UNITED STATES PATENT AND TRADEMARK OFFICE

09/788,420

Office Action Summary	Application No. 09/788,420	Applicant(s) KWON ET AL.	
	Examiner TIMOTHY L. RUDE	Art Unit 2871

FIG. 1E
CONVENTIONAL ART

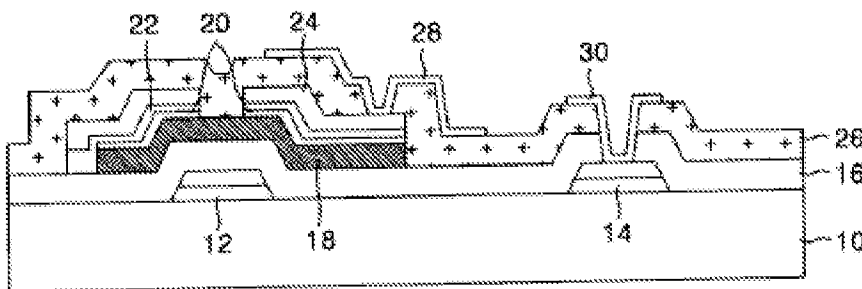
As to claims 1 and 8-9, APA discloses a liquid crystal display (LCD) device (Fig. 1E) having a substrate (10), a first conductive layer (12A with no 12B; 12B is optional per Applicant's specification, page 9, per amendment filed 08 May 2007) and a pad layer (14A) on the substrate, wherein the first conductive layer and the pad layer are patterned from the same conductive layer; a first insulating layer (16) on the substrate, the first conductive layer and the pad layer, the first insulating layer having a contact hole (above 14A) exposing a portion of the pad layer; (allowing electrical connection to 14A via contact hole above 14A);

a semiconductor layer (18) on the first insulating layer;
second conductive layers (20) on the semiconductor layer,
third conductive layers, (22A and 24A), on the second conductive layers,
a second insulating layer (26) on the third conductive layers, the second insulating layer having a first contact hole exposing a portion of the third conductive layers (contact hole for pixel electrode) and a second contact hole (hole for 30) exposing the portion of the pad layer through the first insulating layer,
a first adhesion conductive layer, 24B, on the exposed portion of a third conductive layer and a second adhesion conductive layer, 14B, on the exposed portion of the pad layer, wherein the first adhesion conductive layer is directly contacted with the third conductive layer and the second adhesion conductive layer is directly contacted with the pad layer [per APA Figure 1E];
a fourth conductive layer (28) on the second insulating layer and the first adhesion conductive layer and electrically contacting a portion of a third conductive layer;

a fifth conductive layer (30) on the second insulating layer and the second adhesion conductive layer and electrically contacting the pad layer.

Please note, this is a device claim whereby "formed in" is considered to limit where structure is as opposed to how it got there. Also, something that is at the bottom of a hole is reasonably considered to be in the hole.

APA does not explicitly disclose an embodiment wherein the first and second adhesion conductive layers are respectively contained within the first contact hole and in the second contact hole.

as an art recognized configuration suitable for the intended purpose of improving adhesion of the overlying conductive layer with the underlying conductive layer [col. 12, lines 4-34] which would improve yield and reliability [MPEP 2144.07]. This would result in a change of configuration from that shown in Applicant's Figure 1E (elements 12A and 14A) to Applicant's Figure 3E (to corresponding elements 34 and 36).

APA teaches that items 12, 14, 22, and 24, in Applicant's prior art Figure 1E may be single or double layer; both are known and used in the prior art [specification pages 2-4].

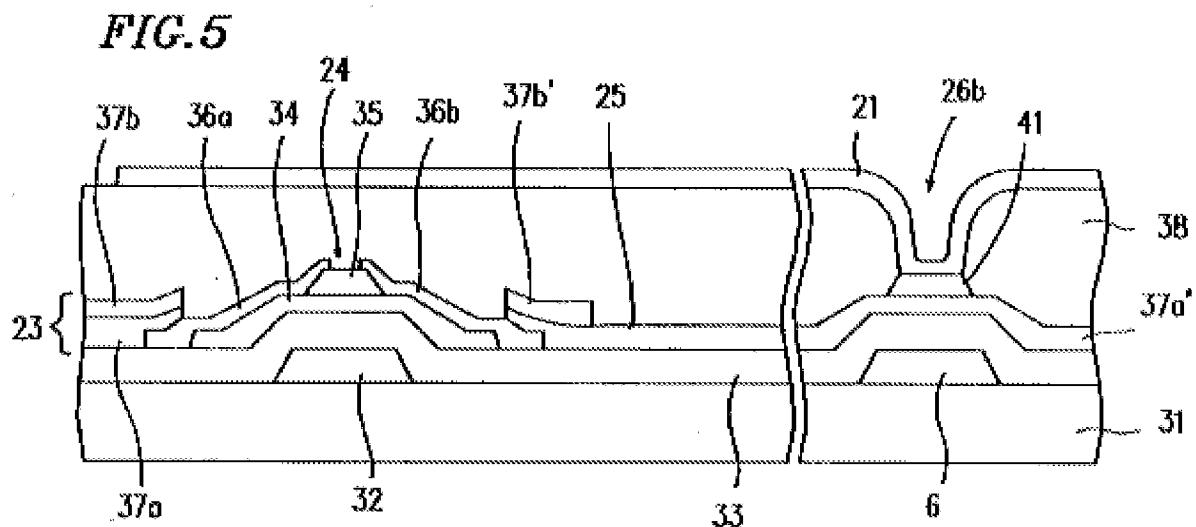
Tagusa teaches at Figure 5 an embodiment wherein such a metal layer, 41, may be deposited [Applicant's "plated"] such that it is exclusively and entirely contained within the contact hole, 26b

as an art recognized configuration suitable for the intended purpose of improving adhesion and electrical connectivity of the overlying conductive layer with the underlying conductive layer [col. 12, lines 4-34] which would improve yield and reliability [MPEP 2144.07].

Tagusa is evidence that workers of ordinary skill in the art would find the reason, suggestion, or motivation to form such a metal layer such that it is exclusively and entirely contained at the bottom of a contact hole

Tagusa teaches that such a metal layer, 41, may be deposited such that it is exclusively and entirely contained at the bottom of a contact hole, 26b [col. 12, lines 11-34],
